Subject: McGuire Nuclear Station
Docket Numbers 50-369 and -370
Catawba Nuclear Station
Docket Numbers 50-413 and -414
Technical Specification Revision to Change Method of
Measuring Reactor Coolant System Flow Rate; Supplemental
Information

REQUEST FOR ADDITIONAL INFORMATION
REACTOR COOLANT SYSTEM (RCS) FLOW MEASUREMENT METHODOLOGY

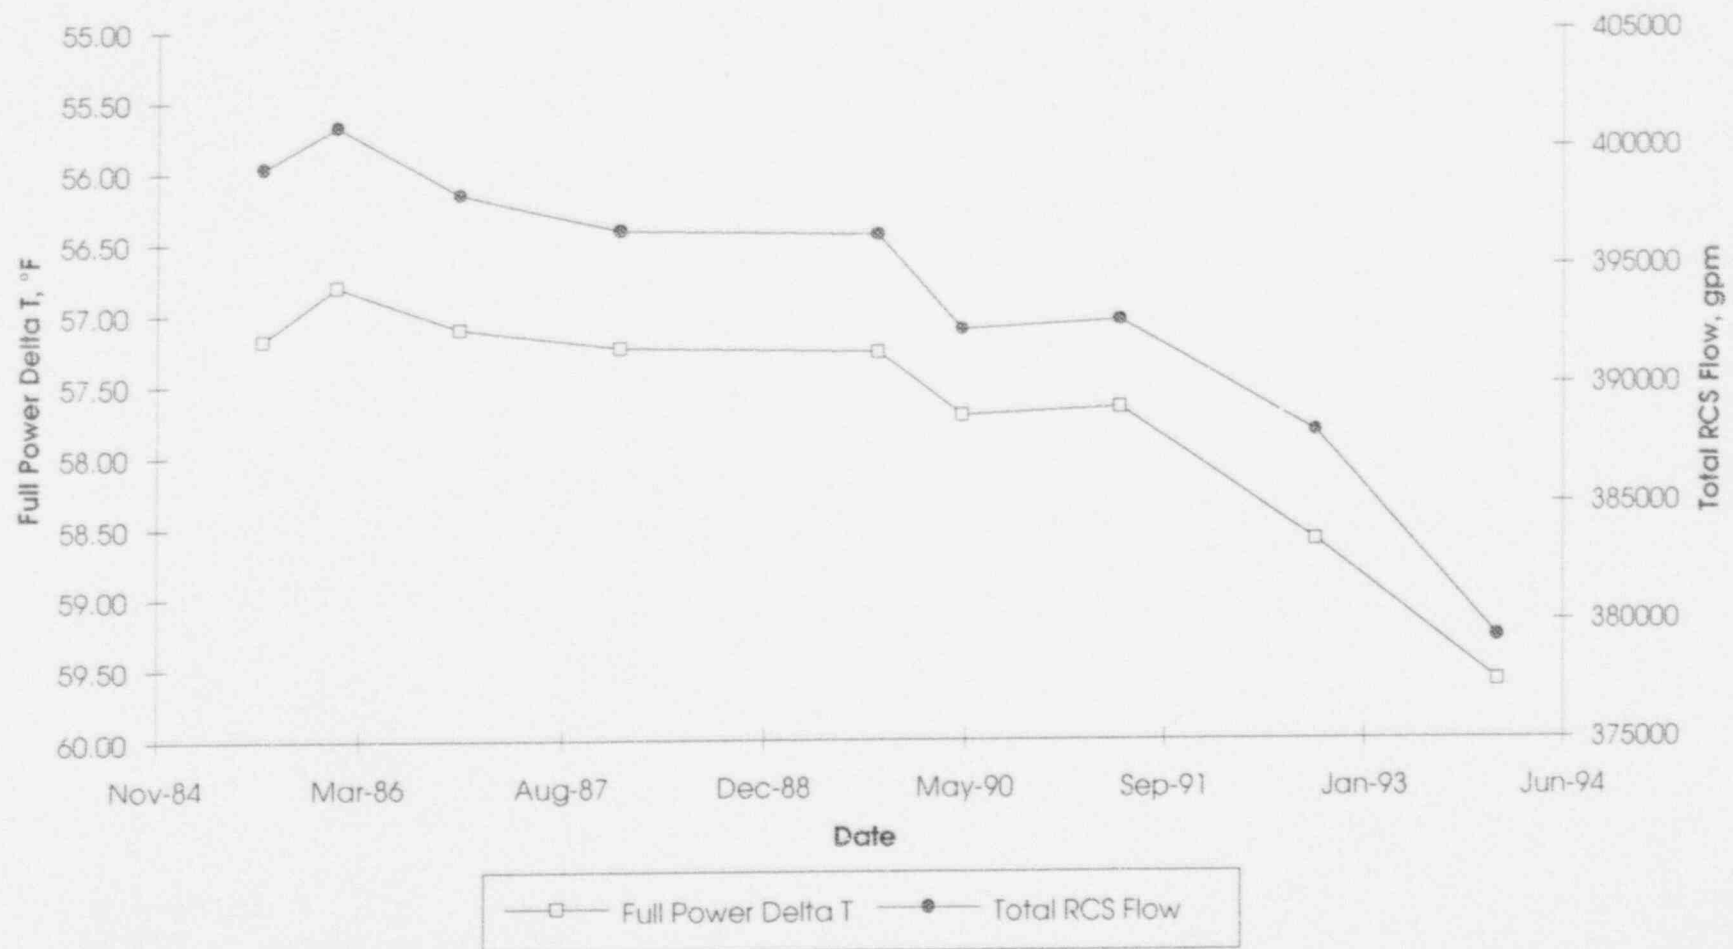
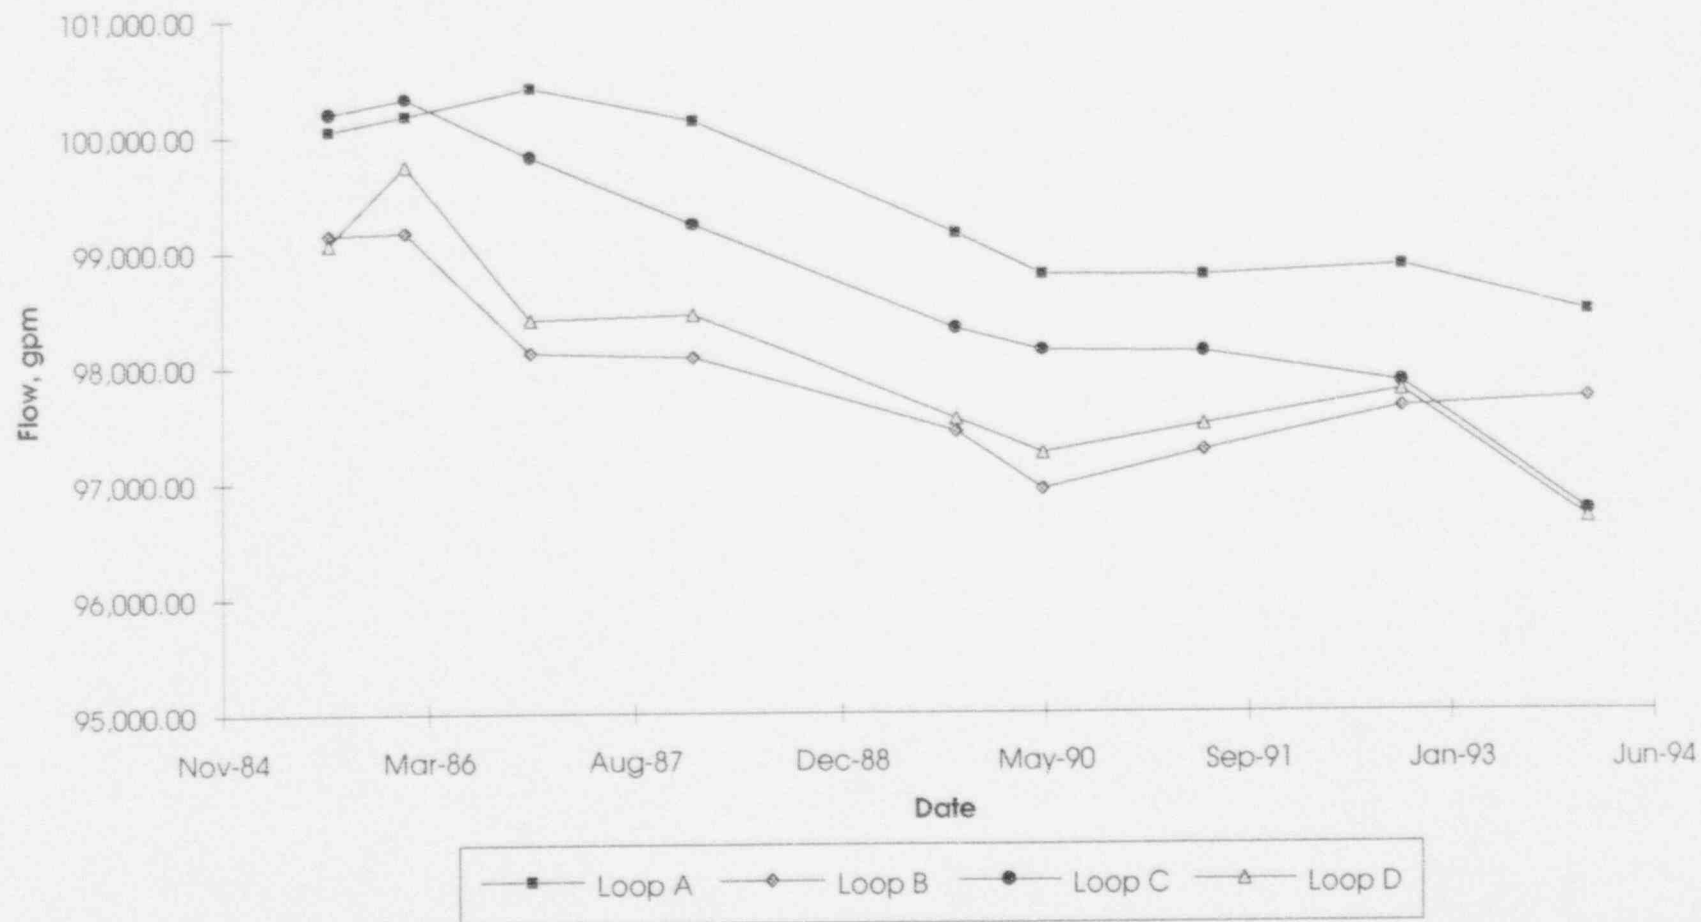
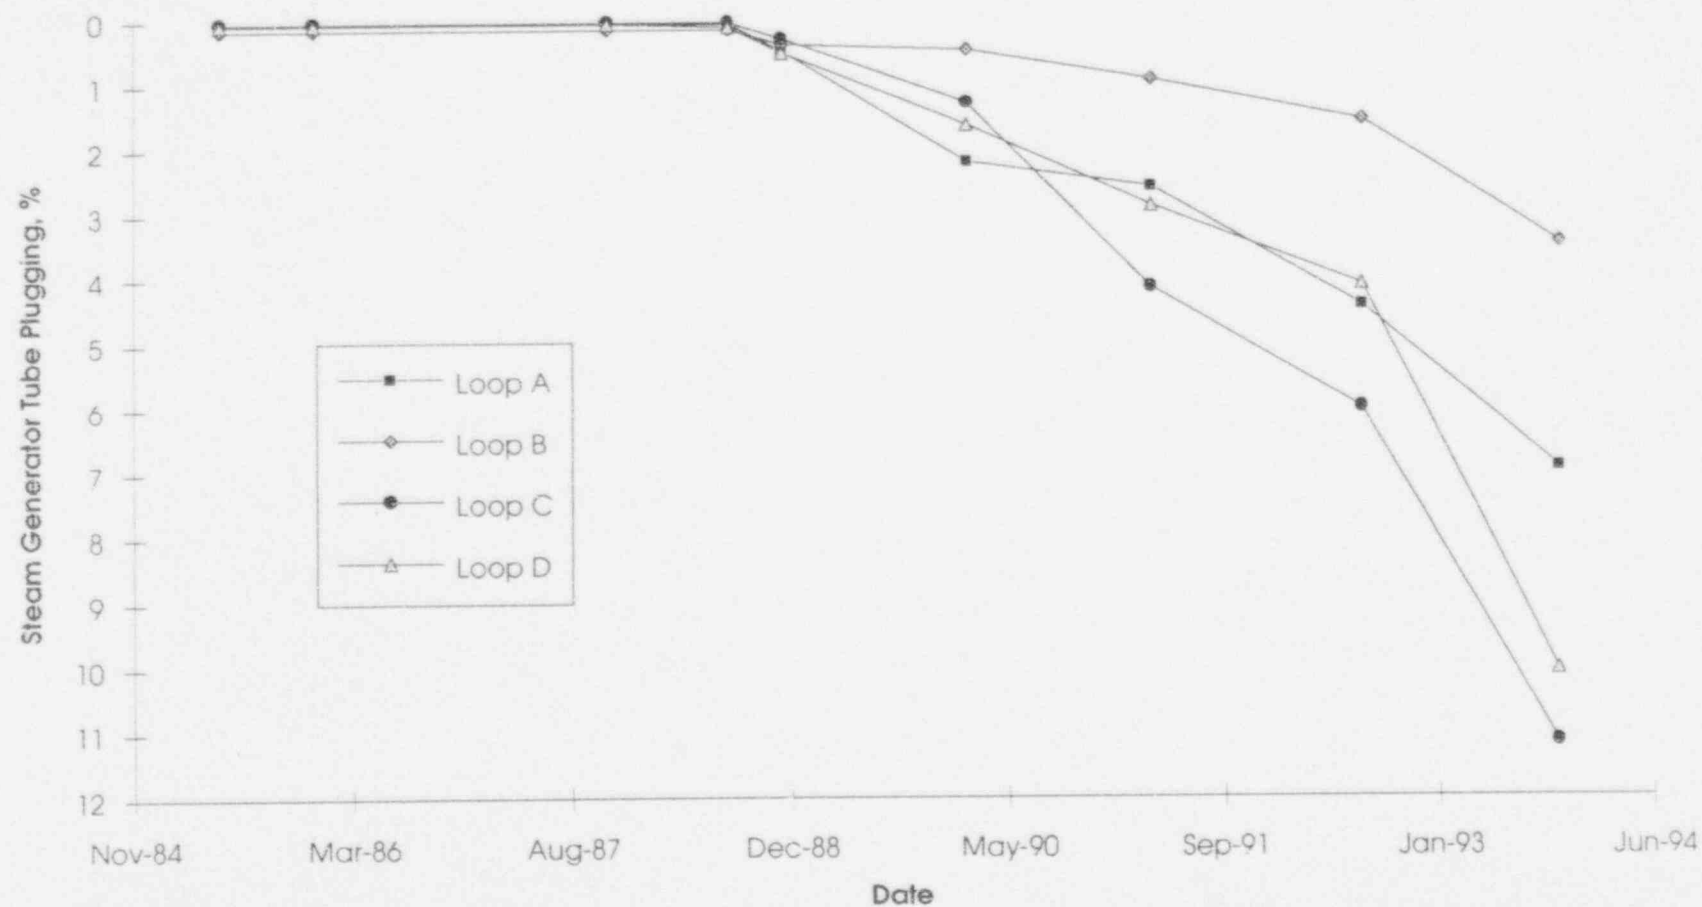
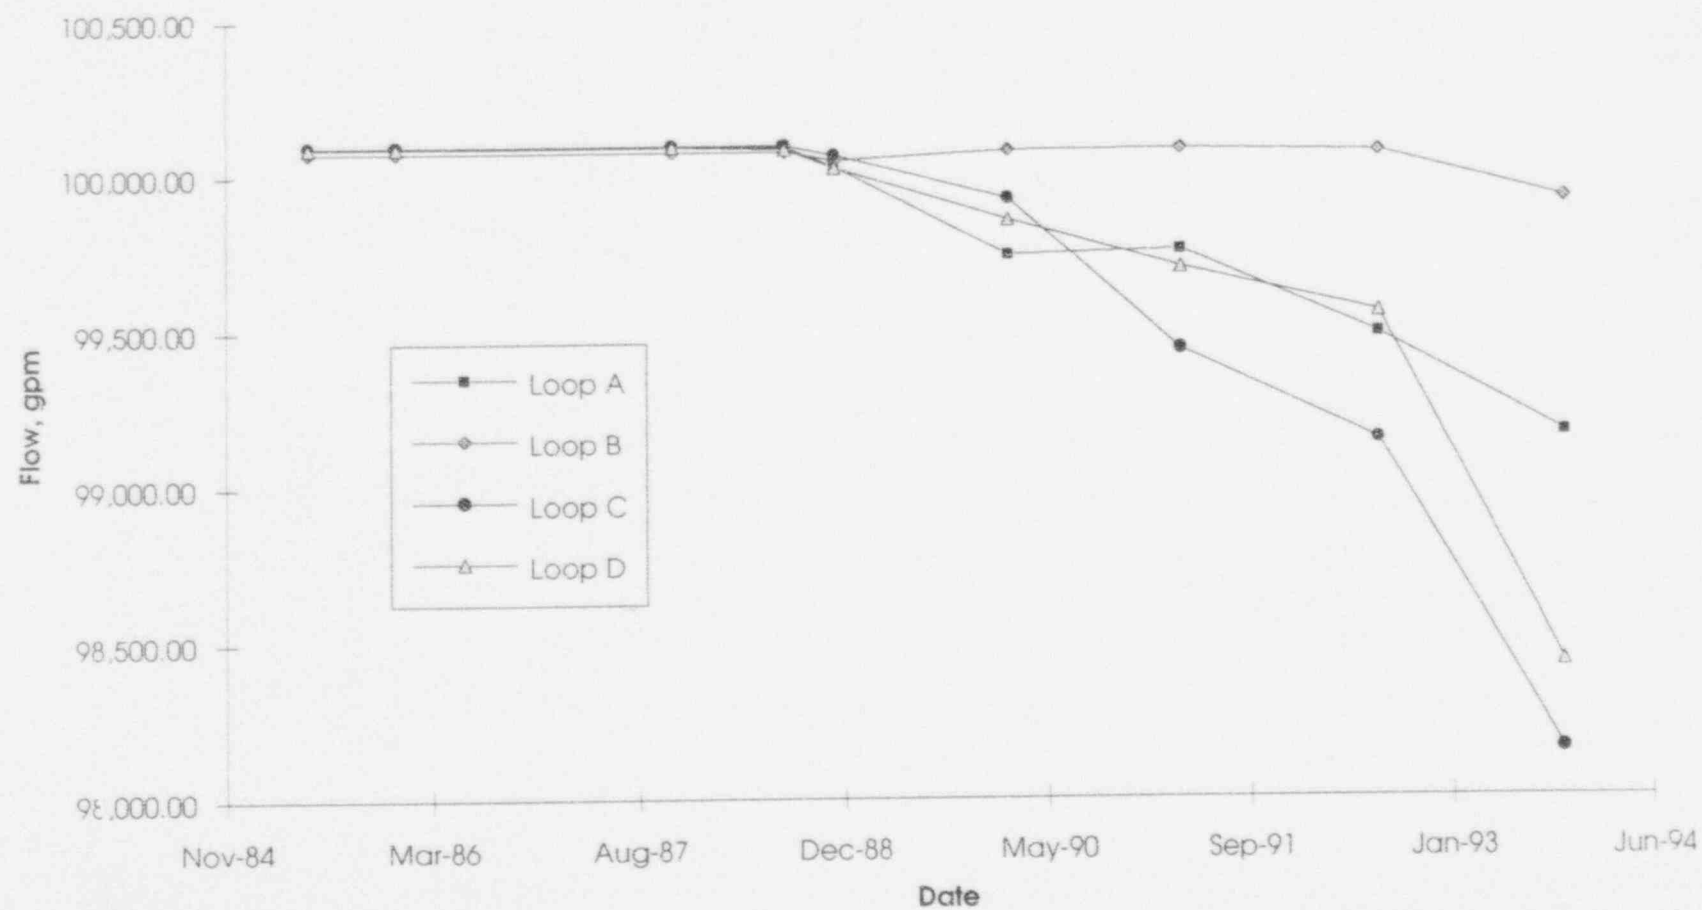
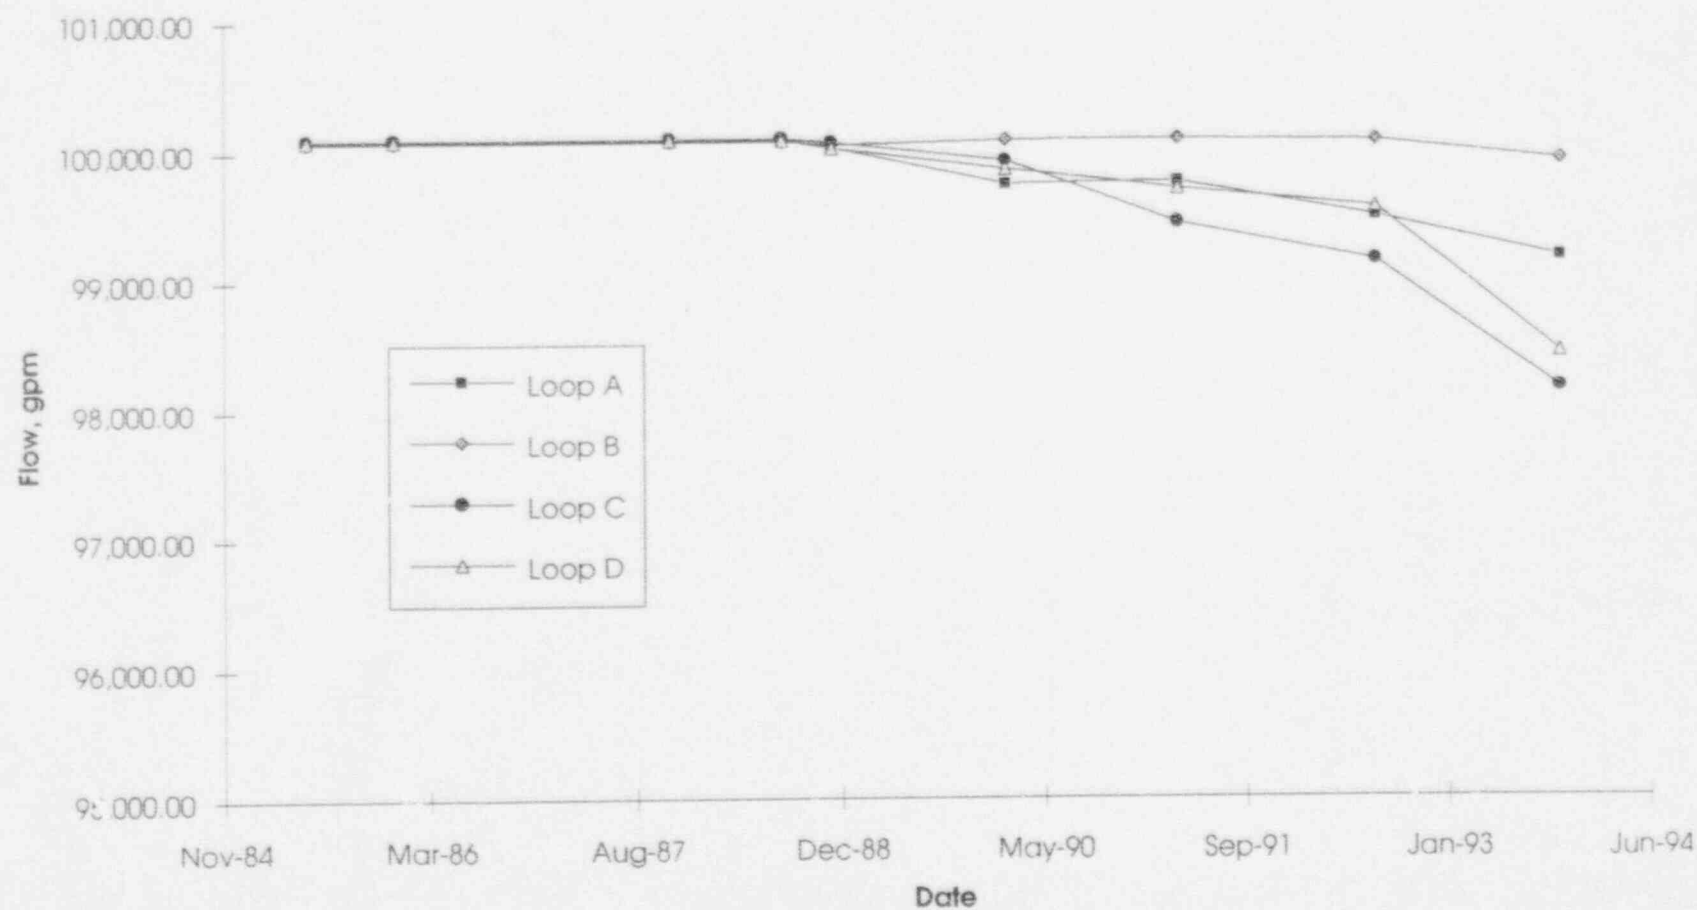
- (13) The data presented on the handouts in the February 10, 1994, meeting shows that the flow rate indicated by the calorimetric heat balance method approximates that indicated by the elbow taps except for the McGuire Unit 2 in 1985, Catawba Unit 2 up until 1990 and Catawba Unit 1 in October 1992 and January 1994. Provide an assessment for each of these divergencies.

Catawba Unit 1 has experienced substantial flow impact as a result of hot leg streaming in recent calorimetrics. The RCS flow as measured by the calorimetric has trended very closely to the changes in full power ΔT as can be seen in Figure 13. The calorimetrics performed between plant startup and February 1986, following the EOC 1 refueling outage, indicate an unsubstantiated increase in RCS flow which was not accompanied by significant plant changes. The increase in flow was largely the result of ΔP transmitters which drifted excessively. This increase in flow was indicated by the calorimetric (Figure 13) and the elbow tap ΔP flow (Figure 14) since the drift in elbow tap ΔP transmitters affects both methods of flow measurement. The analytical flow model does not predict any flow changes during this period as no changes to plant geometry were made (Figures 15, 16 & 17). Note, Figures 16 & 17 differ only in the Y-axis scale with the scale on Figure 17 matching the scale of Figure 14 for easy comparison.

The calorimetric flows following the November 1987 calorimetric have basically trended downward consistent with the increasing trend in ΔT , but in excess of that expected by plant geometry changes. Since plant startup the calorimetrics have indicated that the total RCS flow has dropped approximately 21,000 gpm (Figure 13) whereas the elbow tap and analytical model flow have indicated a drop in total flow of approximately 9,000 gpm and 5,000 gpm respectively (Figures 14 & 16). The difference between these flow indications is the excess elbow tap ΔP transmitter drift during the early calorimetrics which caused the

unsubstantiated indicated flow increase. This indicates a significant impact from hot leg streaming as it shows that 12,000 to 16,000 gpm of the calorimetric flow decrease can be attributed to this phenomenon.

The first batch of B&W fuel was introduced during the April 1991 EOC 5 refueling outage. The B&W fuel was expected to increase flow slightly due to the decreased flow resistance in the core. This increase in flow due to the new fuel was expected to be offset by steam generator tube plugging as shown in Figures 16 & 17. In fact, the flow in the plant as indicated by the elbow tap ΔP s and the calorimetric actually increased slightly after this outage. This is likely due to the new fuel having a greater effect on the flow than anticipated and partially due to the analytical flow model assumption that 1/3rd of the core would be replaced when slightly more was in fact replaced ($\approx 37\%$). The August 1992 EOC 6 and November 1993 EOC 7 refueling outages, which include the second and third batch of B&W fuel and additional steam generator tube plugging, resulted in substantial flow decreases as measured by the calorimetric. The elbow tap ΔP flows indicate a slight flow increase resulting from the EOC 6 and a decrease in flow from the EOC7 refueling outages. The analytic model flows, however, indicate a slight decrease in flow after both outages.

The decrease in RCS flow for Catawba Unit 1 during the October 1992 and January 1994 calorimetrics was the result of hot leg streaming changes which resulted in an increased indicated ΔT . The Catawba Unit 1 plot of indicated full power ΔT in Figure 9 shows that the indicated ΔT for the October 1992 and the January 1994 calorimetric increased approximately 1 °F each. These two increases in ΔT represent a decrease in flow of approximately 12,750 gpm while the changes in elbow tap ΔP indicate a flow decrease of approximately 2,100 gpm. Steam generator tube plugging was performed during the outages prior to these calorimetrics (Figures 11 & 12), however, the magnitude of the elbow tap ΔP flow changes is consistent with the analytical model predicted flows which indicates that $\approx 10,650$ gpm of the calorimetric decrease is attributable to hot leg streaming.
